Product Highlights

PCN No: 144

Notice Type: Product Change

Notice Type: Product Revision Change

PCN_125_AL295

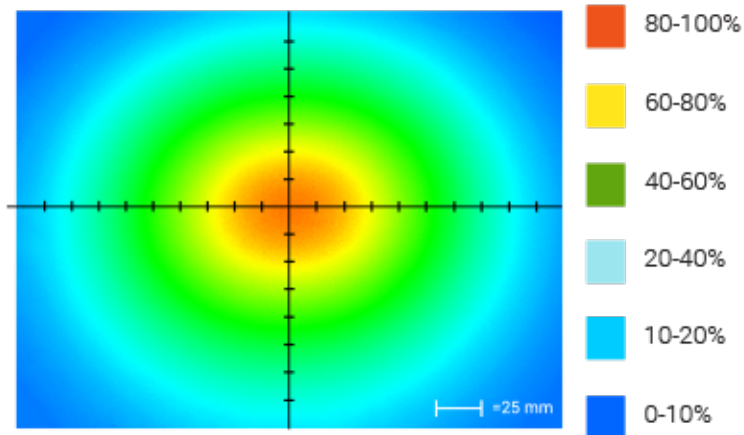
In an effort to improve our products, Advanced illumination (Ai) will update the LEDs used in the AL295 design. This change will result in a brighter, more uniform light at the same price*. Customers may still buy the current revision of this model until September 2th of 2016. After that time, orders for these products will be converted to their respective AL295 Revision A models.

This LED change will result in additional wavelengths being available: 365nm, 375nm, 385nm, 395nm, 405nm, 470nm, 505nm, 590nm, 660nm, 730nm, and 940nm. Additionally the white LED color temperture will be changing from 6100K to 5500K.

*UV wavelengths (365nm, 375nm, 385nm, 395nm & 405nm) will be sold a higher list price, which will be released at the time of product introduction.

Orders for customized (dash numbers) versions of AL295 will be honored until January 13th of 2017. Ai will be actively working with customers for those products to simplify the transition.
